SUNSET VILLAGE FILING NO. 4

CONSTRUCTION PLANS

EPC STORMWATER REVIEW COMMENTS
IN ORANGE BOXES WITH BLACK TEXT

Figure 2-36. Access Ramp Locations at "T" Intersections

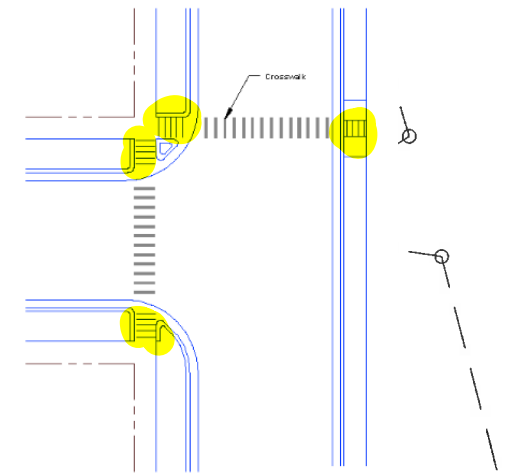
Unresolved. Per Figure 2-36 only two of the intersection legs need pedestrian crossing. Delete one of the pedestrian crossing on Pipestem Dr.

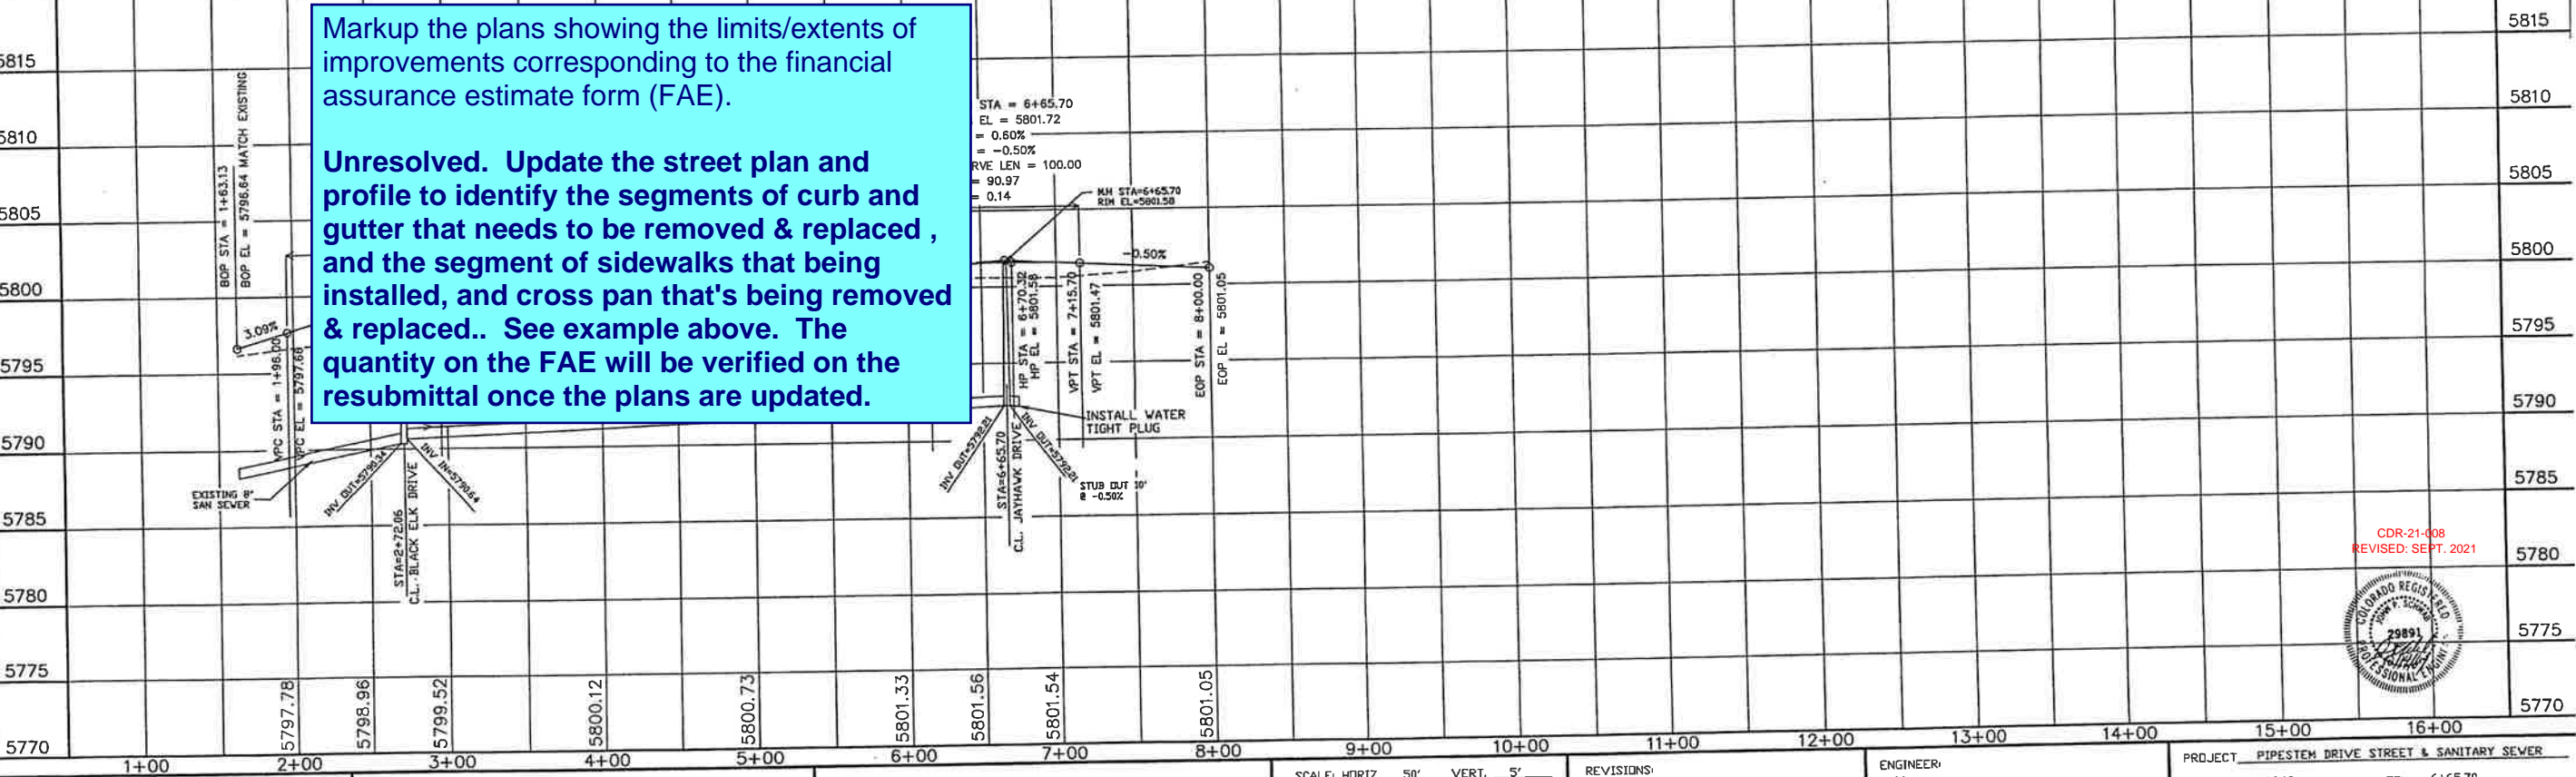
Remove the existing ramp with no receiving ramp on Pipestem Dr and replace with Type A C&G.

update street plans to show installation of sidewalk ramps at the opposite side of the street at all T-intersections of the subdivision per criteria

Remove the crosswalk striping

Example callout: "Remove & replace 25 LF of C&G from STA 3+75 to 4+00"

Markup the plans showing the limits/extents of improvements corresponding to the financial assurance estimate form (FAE).
Unresolved. Update the street plan and profile to identify the segments of curb and gutter that needs to be removed & replaced, and the segment of sidewalks that being installed, and cross pan that's being removed & replaced.. See example above. The quantity on the FAE will be verified on the resubmittal once the plans are updated.

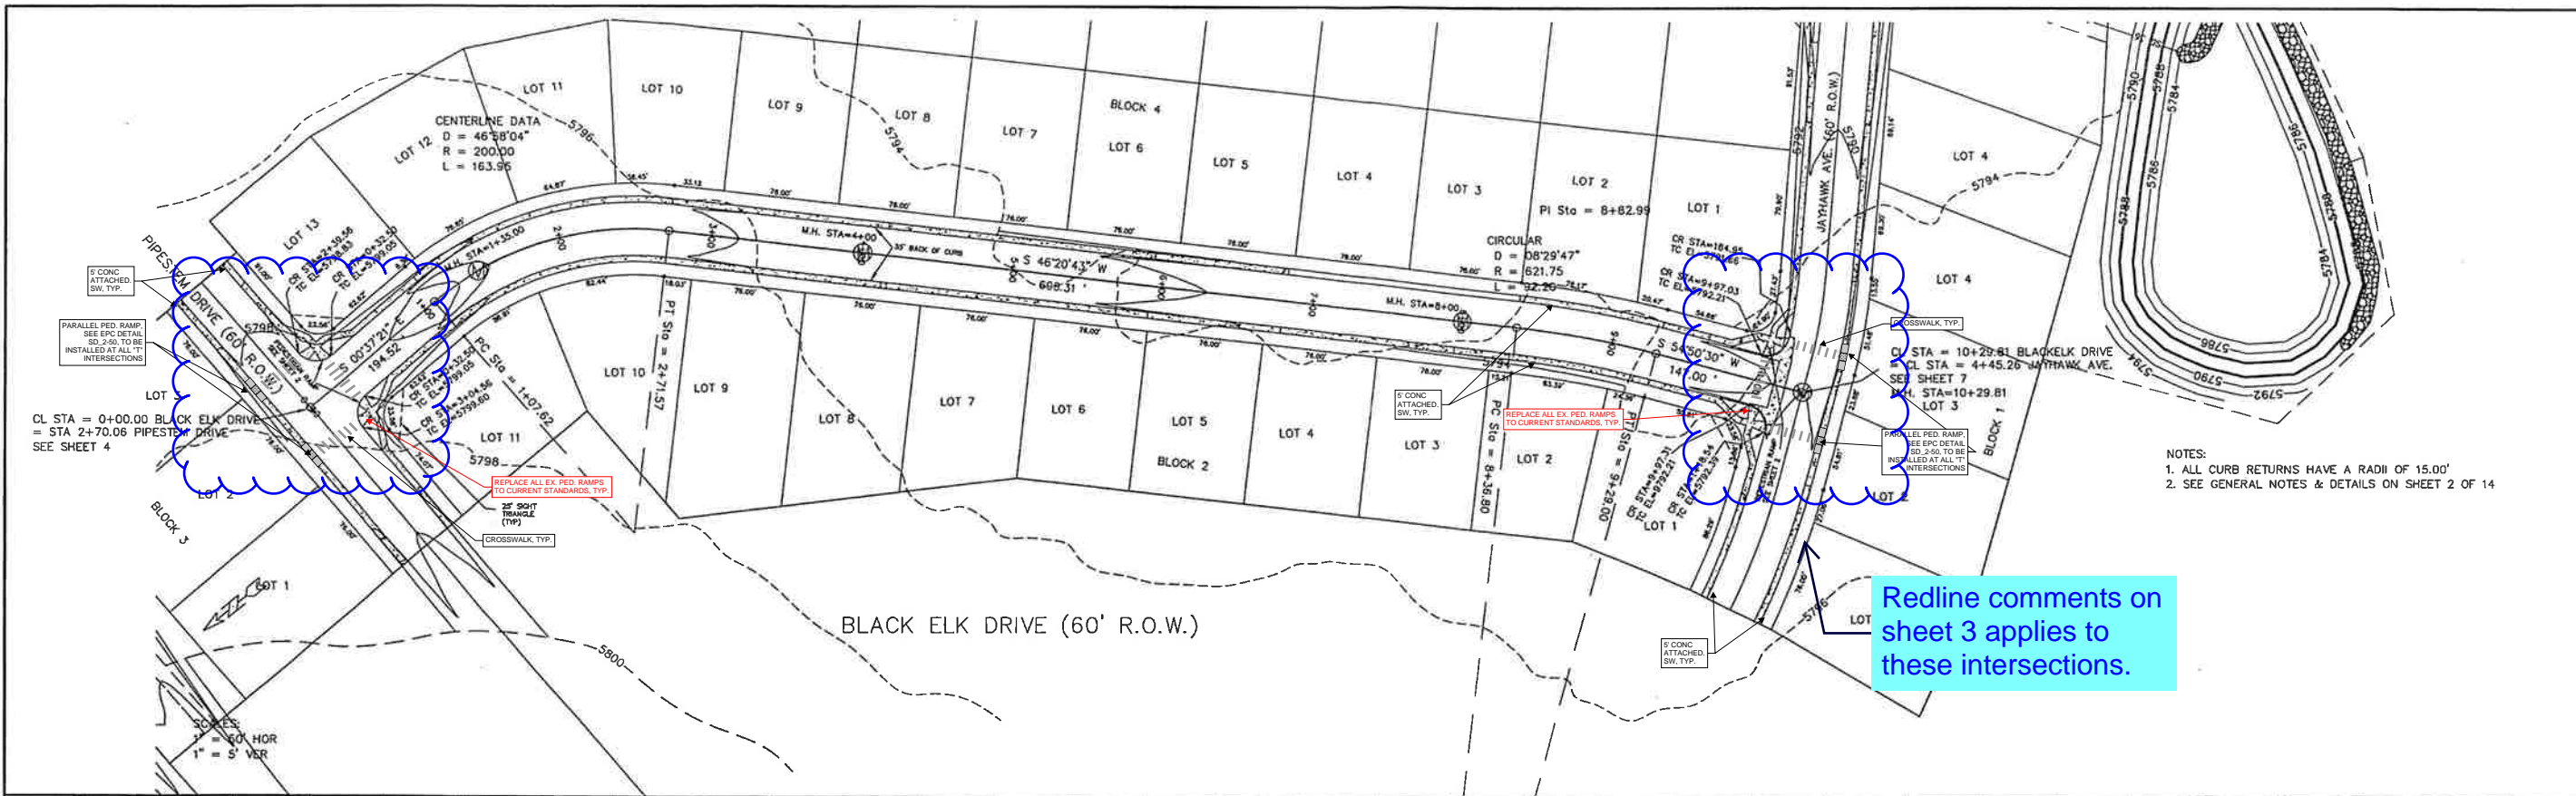
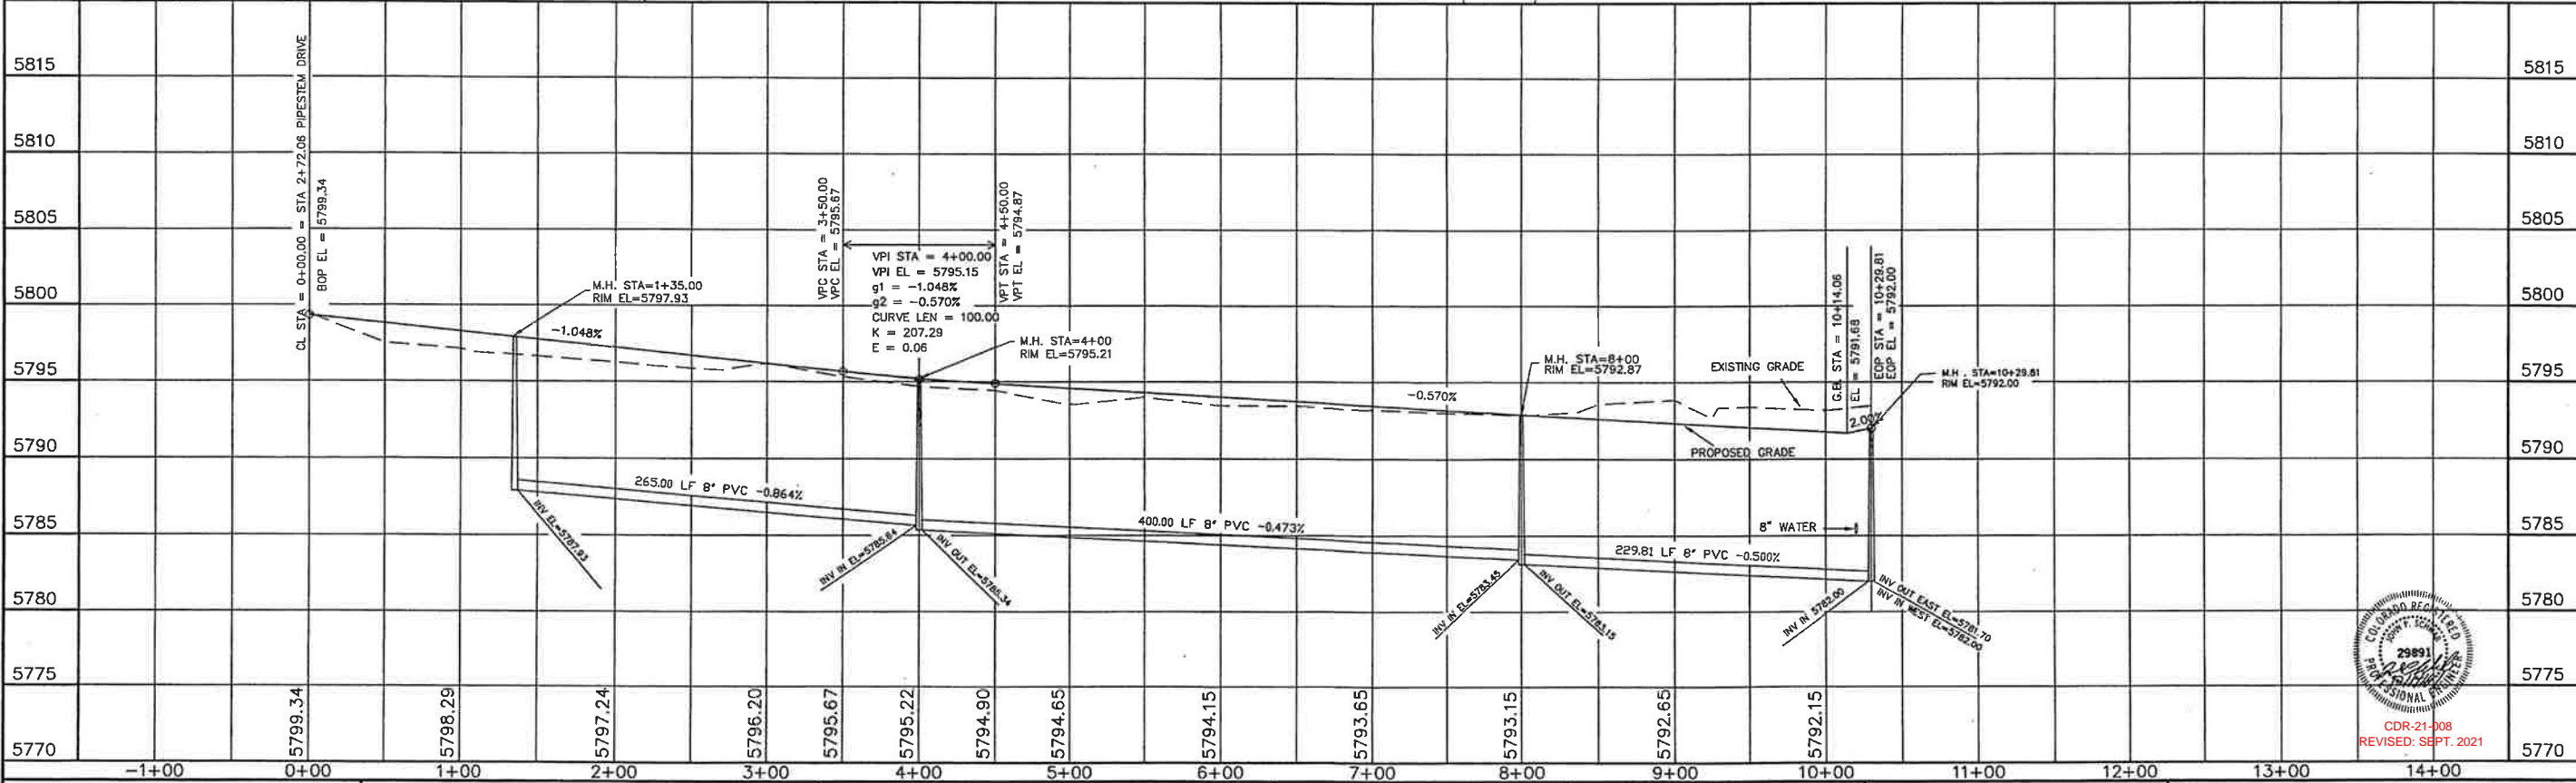
Redline comments on sheet 3 applies to these intersections.

DEVELOPED DRAINAGE & EROSION CONTROL PLAN

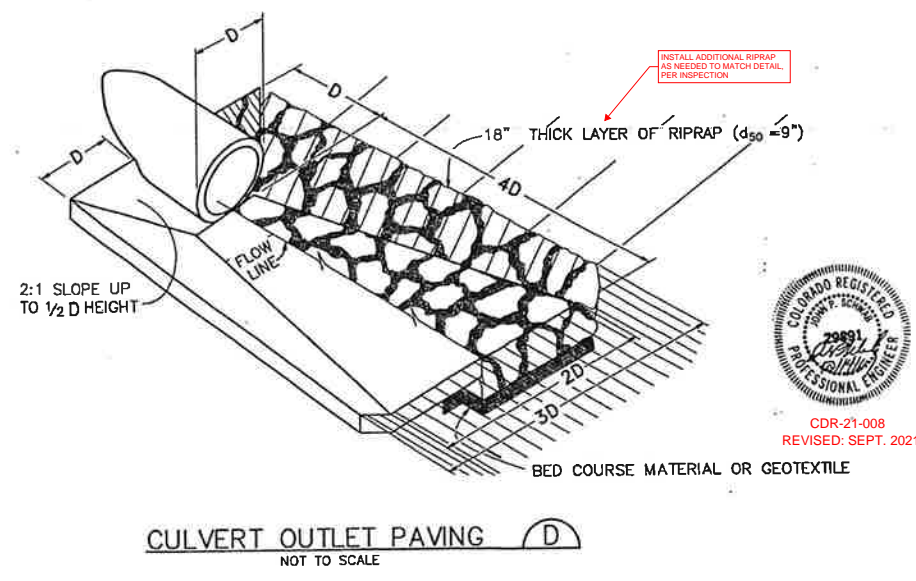
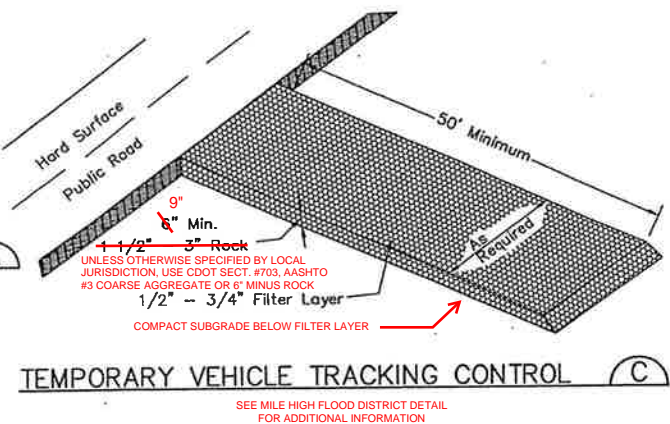
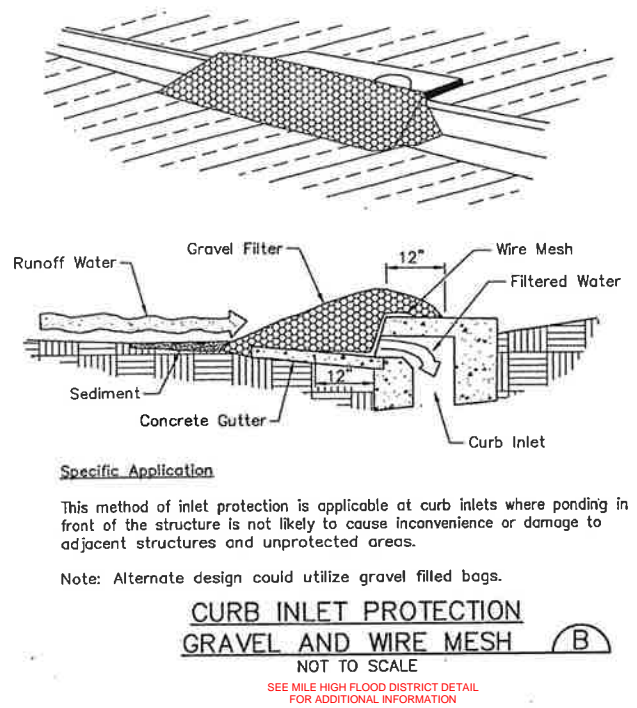
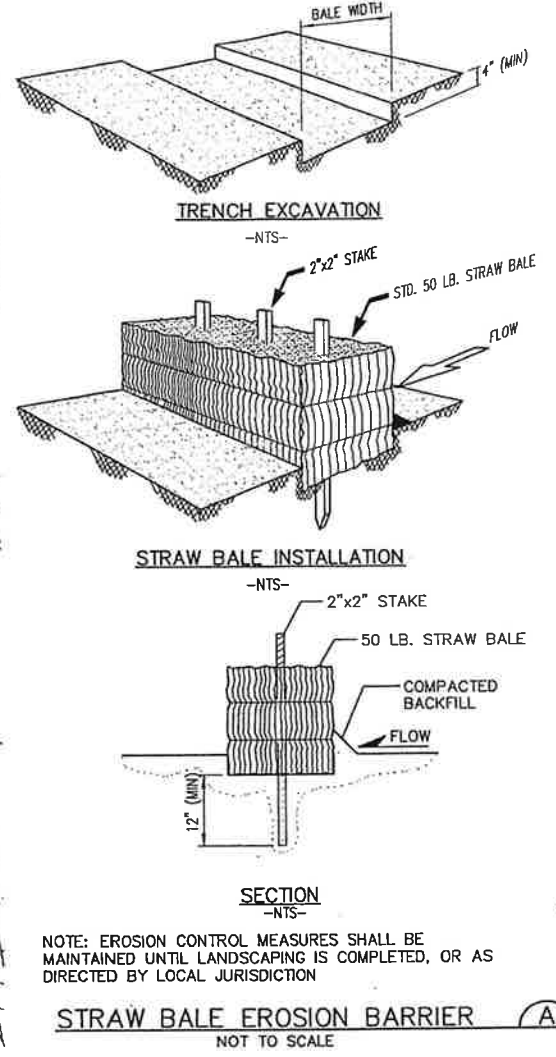
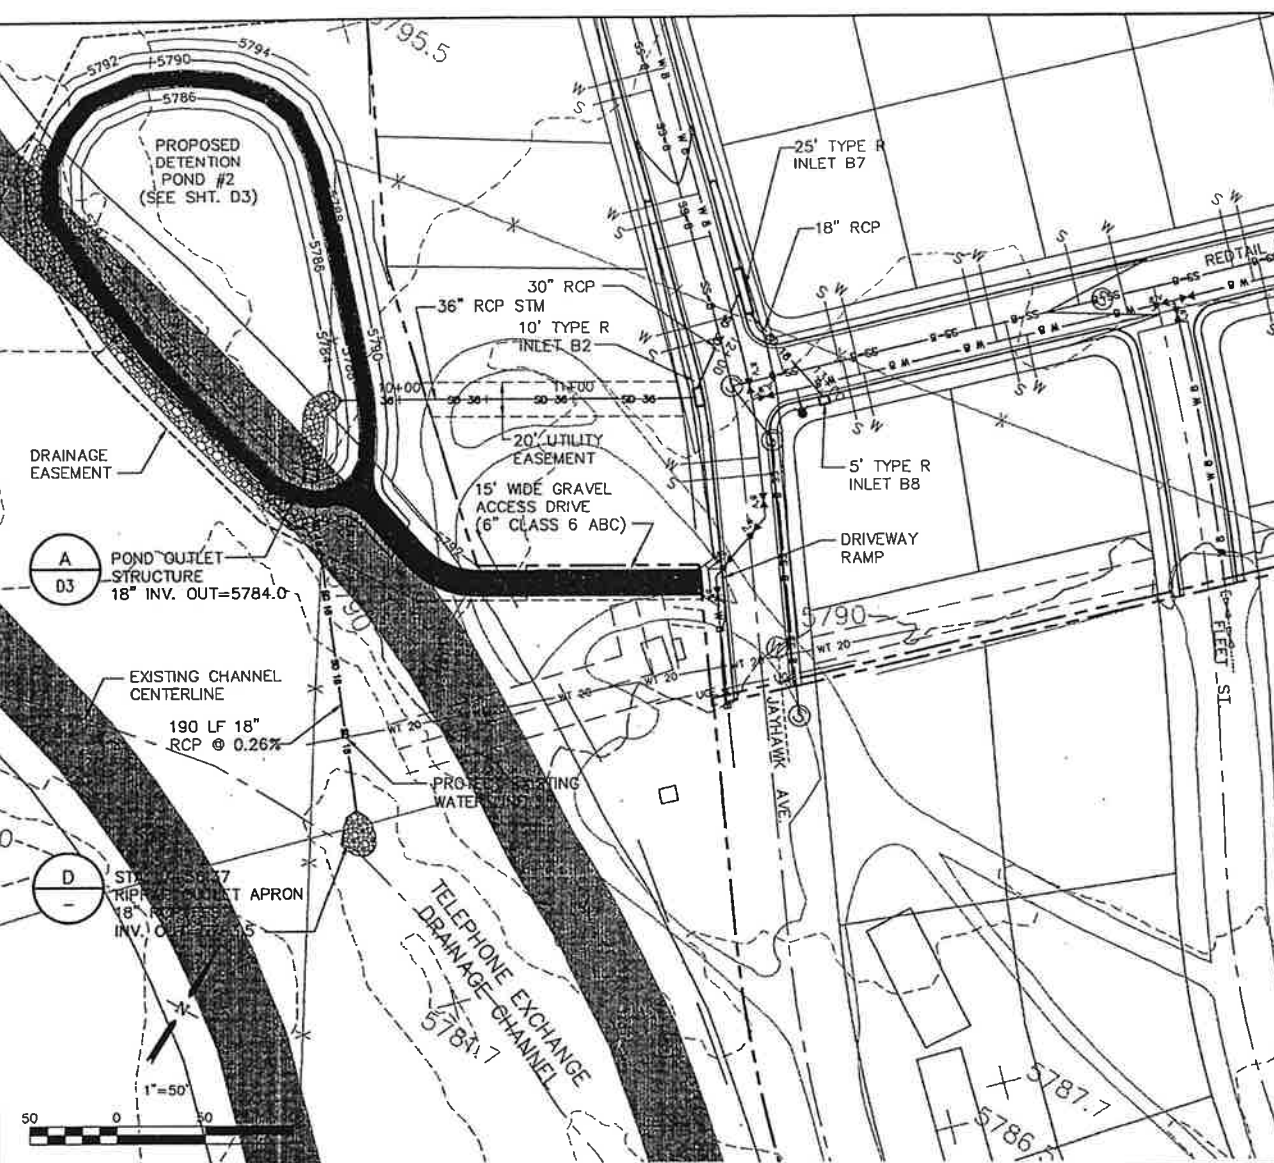
Remove VTC if not required with the remaining work for Filing 4 and update the financial assurance estimate

Place VTC(s) as needed closer to the entrance to function for all construction vehicles exiting the site.

Checklist items H and M - show both on plans and legend. If "limits of disturbance" and "construction boundary" are the same, can make one linetype for "limits of construction/disturbance" or otherwise show as separate linetypes for each on the legend and figure.

Label all proposed temporary construction BMP's by phase of implementation (initial, interim, final) - via labels in parenthesis next to each BMP in the legend and/or via a table on the plans outline which BMP's are installed at which stage.

Not advisable to place this at near the low point of the site within the flow path of runoff --- if the adjacent inlet clogs and overflows, the CWA will be washed out. See MHFD detail MM-1 for recommended placement.

DETENTION POND PLAN & DETAILS

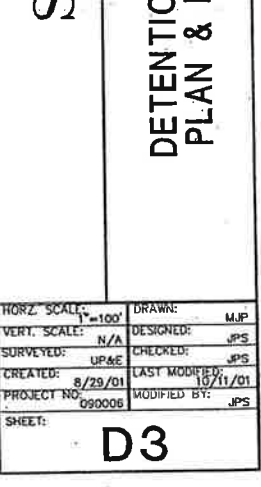
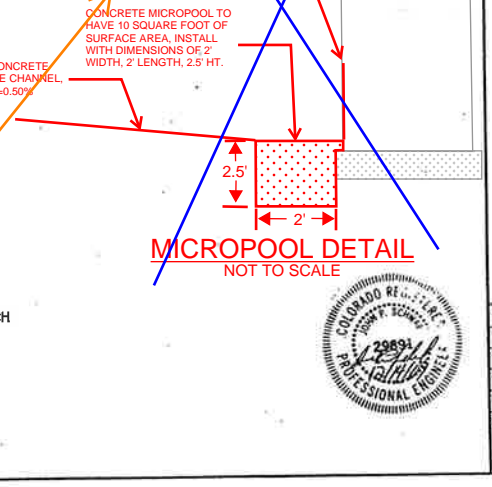
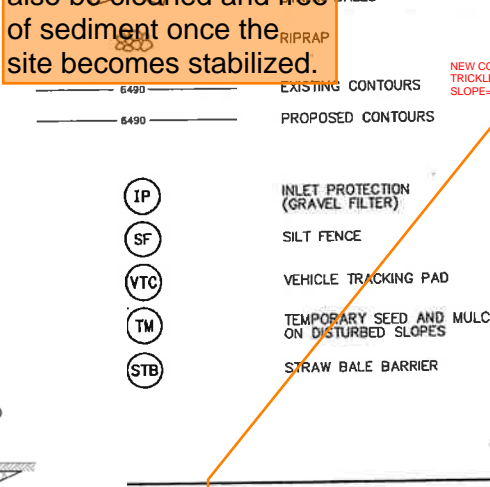
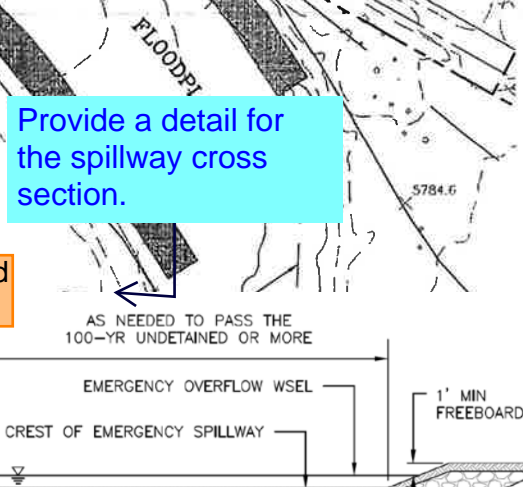
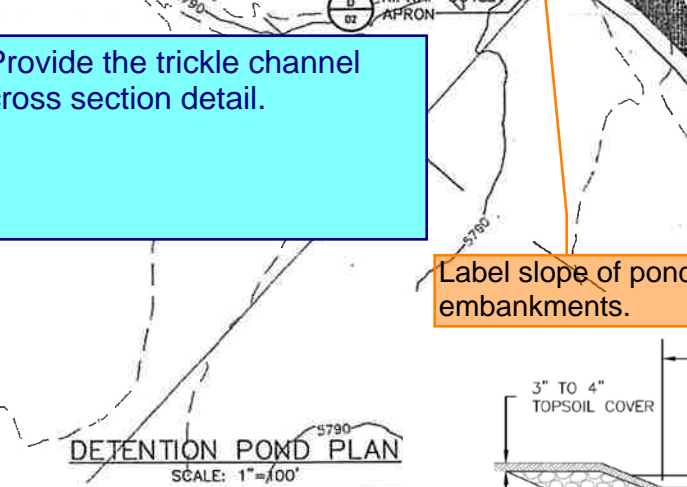
Add the notes above and modify for site specific requirements.

Do not add the notes with strike through. These are notes for the designer to consider and incorporate into the outlet structure design.

Show a pond maintenance access road from Jayhawk Ave to pond and from top of pond down to bottom of pond.

Stabilized access ramp shall be a minimum of 15ft wide and no greater than 12% slope, in accordance with DCMv1, Chap 11.2.2.

Provide roadway detail/cross section, including stone sizing and gradation.

Consider using a base course that will minimize migration of fines when the pond is detaining water.
